CUSTOMER DRAWING DOCUMENT

REPLACING OLDER ENTRELEC OPTICALLY ISOLATED RELAY

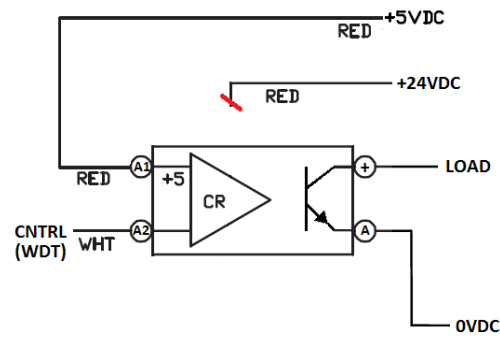
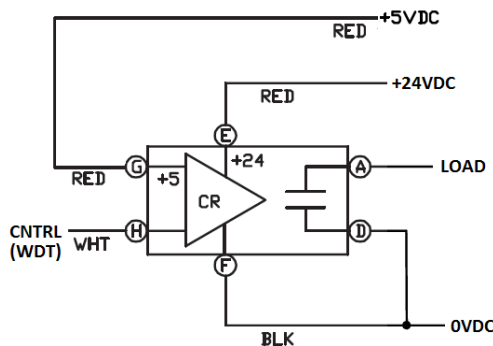
If replacing an Entrelec 0010.131.14 relay (shown below left) – now obsolete by manufacturer – use the revised TE PN 1395831-1 relay (shown below right) along with modified press machine wiring.

The relays wiring terminals have different names but are functionally similar. A typical press application wiring schematic is shown below left with the revised relay and wiring shown below right. The revised relay does not require the use of 24VDC – remove this wire back to its source.
